Product Service Bulletin

MODEL: C2

SUBJECT: SPEAKER GRILLE REPAIR

BULLETIN: 05R

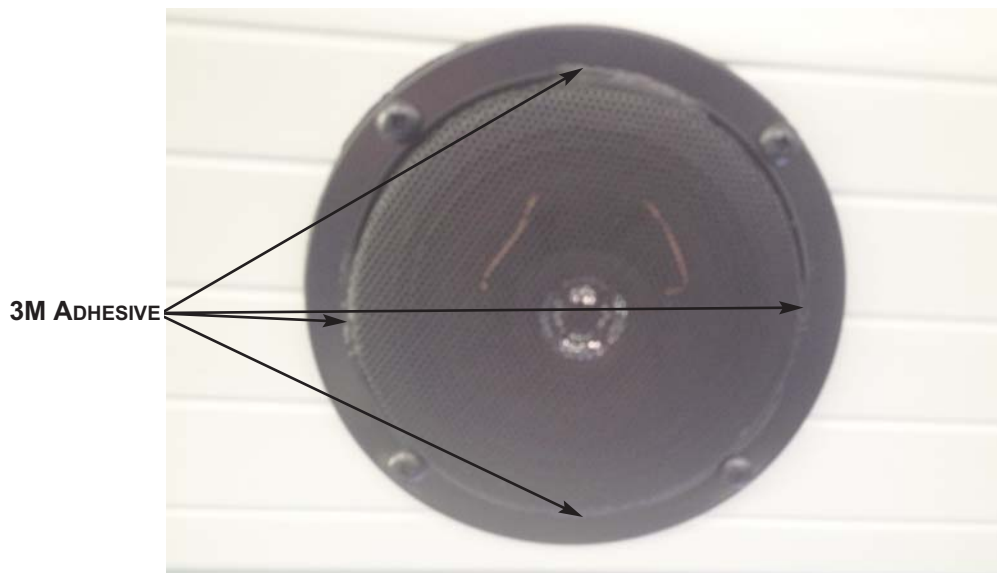
This procedure is for the correction to speaker grilles that may fall off while driving or setting in hot sun. It will keep current grille in place during these times. **This procedure is for buses built before May, 2014.**

1. Chock wheels on bus and put into Park or Neutral.
2. Remove the Ground cable from Batteries.
3. Locate speakers that have grilles that are not staying fastened.
4. Place a small amount of the 3M weather stripping adhesive (approximately ½ inch long) in the areas of 12, 3, 6, and 9 o'clock as shown in picture below.

5. Once the adhesive is placed in the groove in the locations shown, gently push the grille into the groove until flush, all the way around the speaker.
6. Remove excess adhesive from around the outside of the grille.
7. Repeat the same process for each speaker in the bus that has same symptoms.
8. Connect ground cable back to negative side of battery.
9. Un-chock wheels.
